Technical Service Bulletin: TSB210248

New Air Compressor

- KTA19 (All Versions)
- KTAA19 (All Versions)

Figure 2, Representation of Option CP4074.

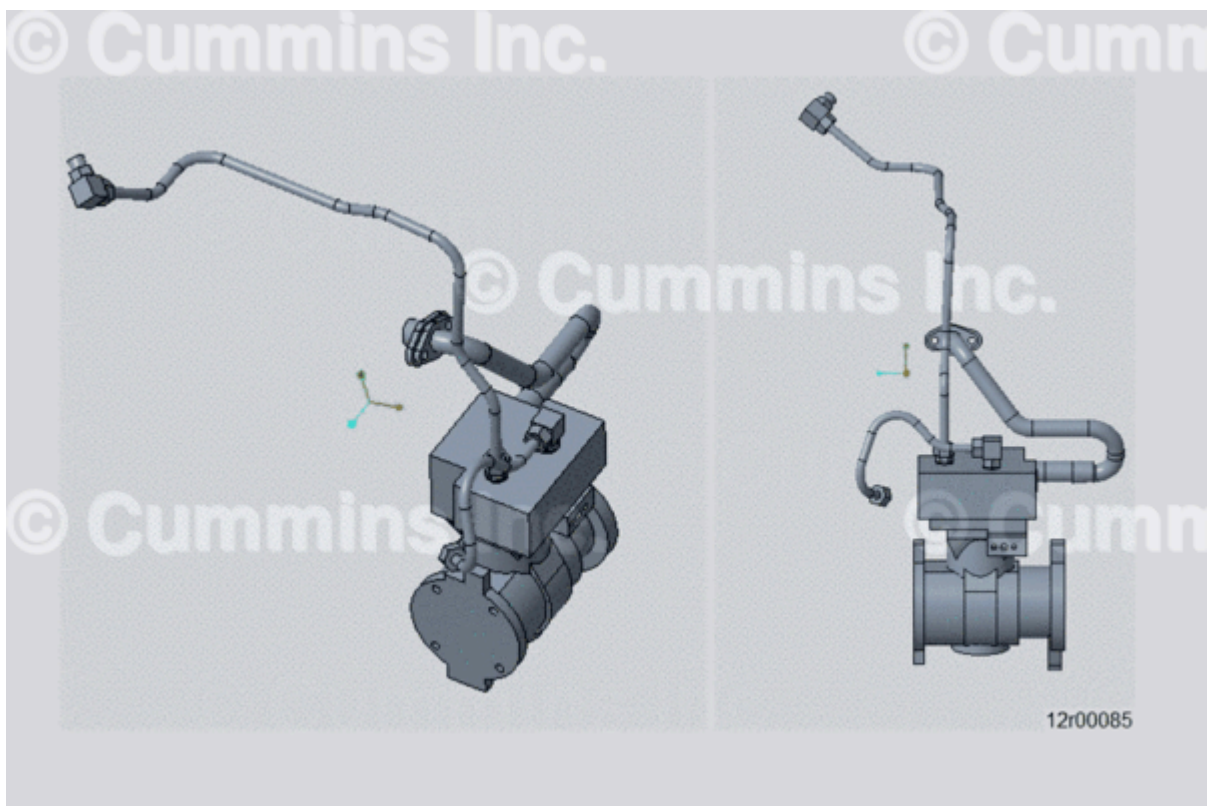
- Current air compressor will be replaced with a pre-existing air compressor.
- This change will result in a slight change in tube routing because of differing placement of coolant ports.
- New option includes addition of inlet water tube.

CP4074 (replaces CP4054)

Figure 3, Representation of Option CP4085.

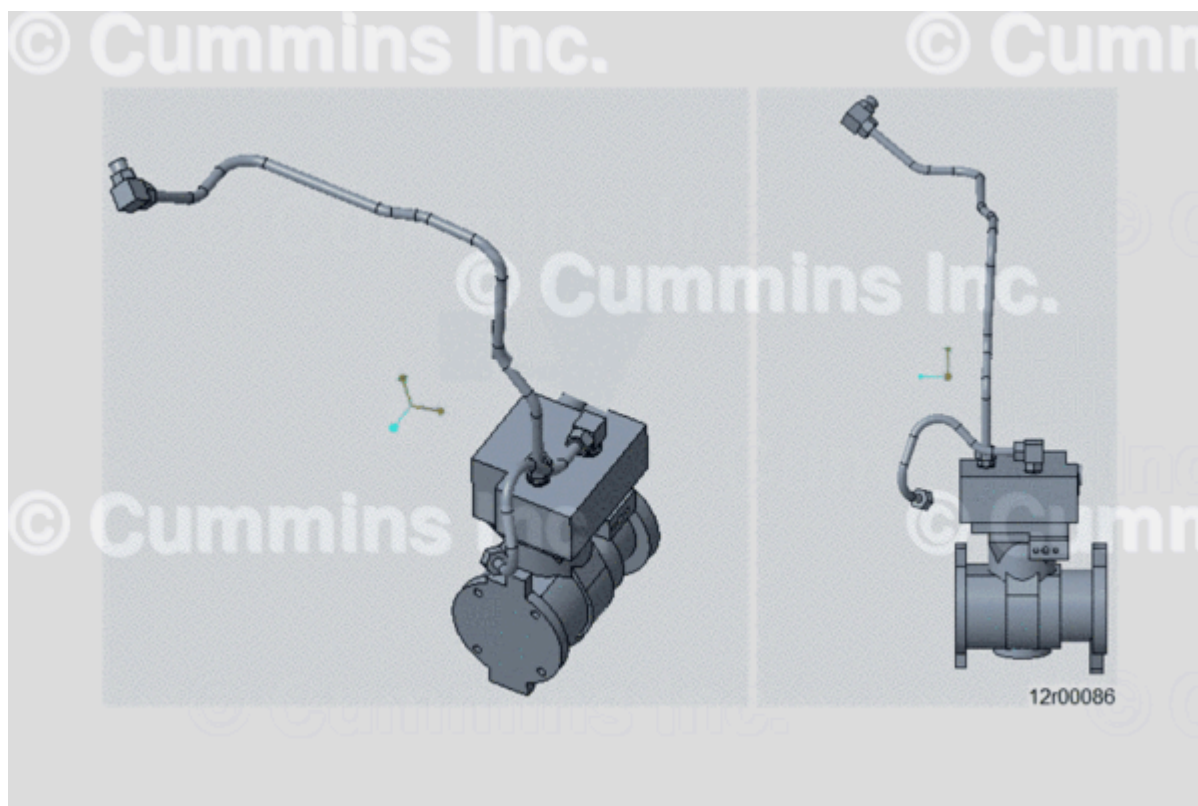
CP4085 (replaces CP4053)
